MISSOURI PUBLIC SERVICE COMMISSION

STAFF REPORT ON

THE EMPIRE DISTRICT ELECTRIC COMPANY

FILE NO. EO-2019-0049

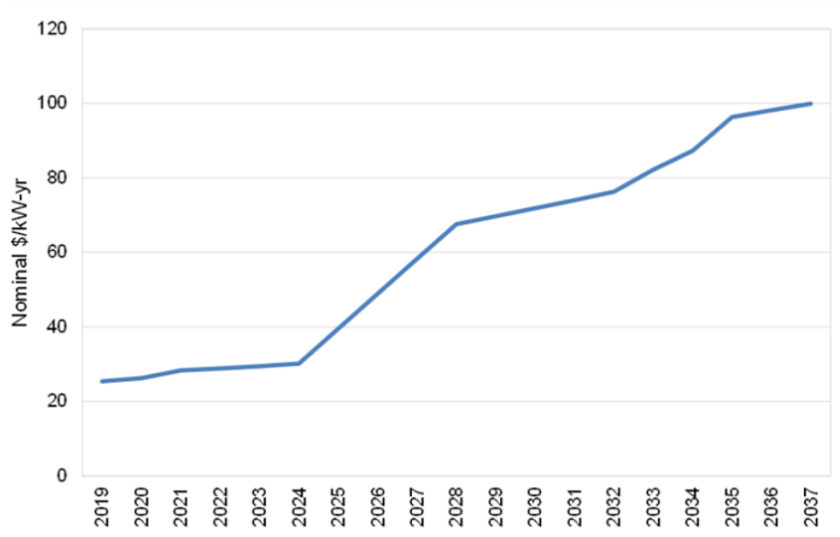
Empire is not compliant with 20 CSR 4240-22.050(5)(A)1. with the calculation of its avoided capacity cost of generation, transmission, and distribution for purposes of DSM program screening. Overstating these costs results in artificial inflation of DSM program cost-effectiveness. The end result is that the model assumes programs are cost-effective when in fact they may not be. Because Empire does not require any supply-side resources to meet

the SPP resource adequacy standard or to provide safe and adequate service to its customers, it is Staff's position that the avoided capacity cost should be zero until such time that Empire can actually avoid costs of capacity. Furthermore, Empire's decision to retire Asbury early may be a driving force for future Empire capacity needs, and may need to be addressed in more detail in another forum. Assuming avoided capacity costs from demand-side programs in the near term while simultaneously retiring Asbury without considering its capacity benefits is inconsistent with 20 CSR 4240-22.060(4).

To remedy this deficiency, Empire should 1) screen demand-side resources using zero avoided capacity costs until Empire needs capacity to meet SPP resource adequacy requirements at which point it could use the most recent ABB Midwest Power Reference Case as the avoided capacity cost for any near term MEEIA application and Chapter 22 compliance filing and calculate the TRC and other cost-effectiveness tests for those demand side programs that pass the screening and 2) select MEEIA programs which have TRCs greater than 1.00²⁹ and are expected to provide benefits for all customers.

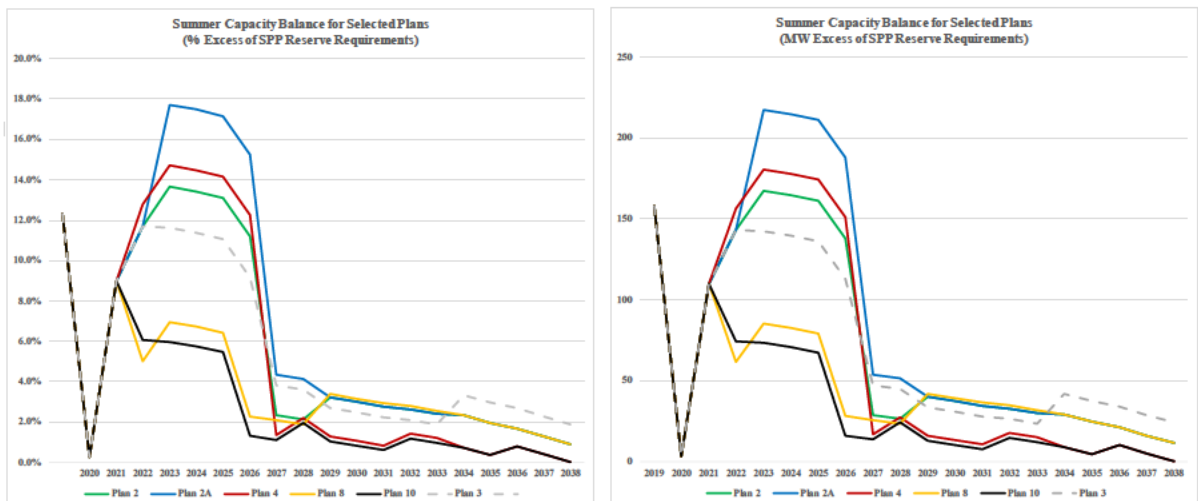
Staff notes that each of the three alternative resource plans which Empire's decision-makers considered as finalist when selecting its preferred resource plan (Plan 2, Plan 2B and Plan 4) each add capacity from 2022 – 2026 in excess of what is necessary to meet SPP resource adequacy requirements.

To remedy this deficiency Empire should develop, analyze and document the performance of three new alternative resource plans which postpone all resource additions in the 2022 – 2023 time frame for Plan 2, Plan 2B and Plan 4 until 2027 when such resources are needed to meet SPP resource adequacy requirements as part of its next Chapter 22 annual update filing. Examples of such alternative resource plans could be Plan 2D, Plan 2BD and Plan 4D in Exhibit 4.

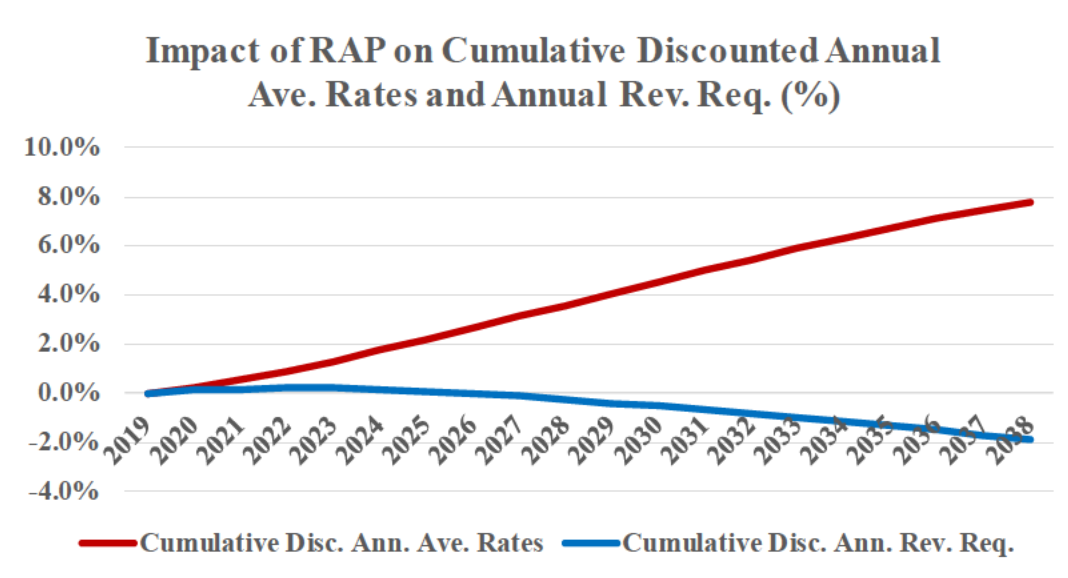
In reference to 20 CSR 4240-22.070(6)(G), Empire states, “The performance measures of the preferred resource plan required by rule for each year of the planning horizon are presented below in Figure 7-17. These measures include: estimated annual revenue requirement; estimated level of average retail rates and percentage of change from the prior year; and estimated company financial ratios. The annual results of the performance measures are illustrated in Figure 7-28 through Figure 7-34 that follow.” Empire did not provide a process for monitoring the progress made toward implementing the preferred resource plan or for reporting significant deviations in a timely fashion to those managers or officers who have the authority to initiate corrective actions to ensure the resources are implemented as scheduled.

To remedy this deficiency, Empire should provide, in its 2020 annual update filing and all future triennial compliance filings, a process for monitoring the progress made toward implementing the preferred resource plan or for reporting significant deviations in a timely fashion to those managers or officers who have the authority to initiate corrective actions to ensure the resources are implemented as scheduled.

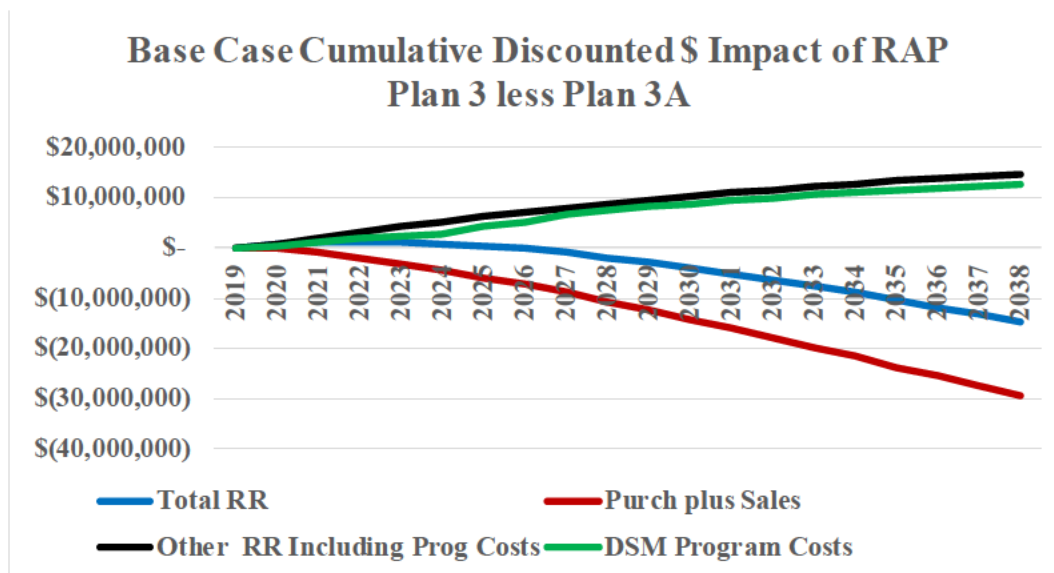
Concern E: Because Empire’s RAP portfolio 1) does not postpone the need for any supply-side resources, 2) derives nearly all of its benefits from a decrease in the revenue requirement for purchases plus sales in the SPP energy market, and 3) because SPP energy market price is a critical uncertain factor, the RAP portfolio is a risky investment for Empire’s customers as a whole, especially those customers who do not participate in the programs, and may not be in compliance with Section 393.1075.4.

Staff’s analysis of data for the Base Case (Iteration 1) from CRA’s integrated resource analyses for Plan 3 and for Plan 3A³⁶ determined that all of the reduction to annual revenue requirements for the RAP portfolio are the result of changes in the energy purchases plus sales in the SPP marketplace and that nearly all of the increase to annual revenue requirements are due to the program cost for demand-side resources.

To remedy this concern, Empire should work with its stakeholders prior to filing any MEEIA application to help assure that such a MEEIA application complies with MEEIA.
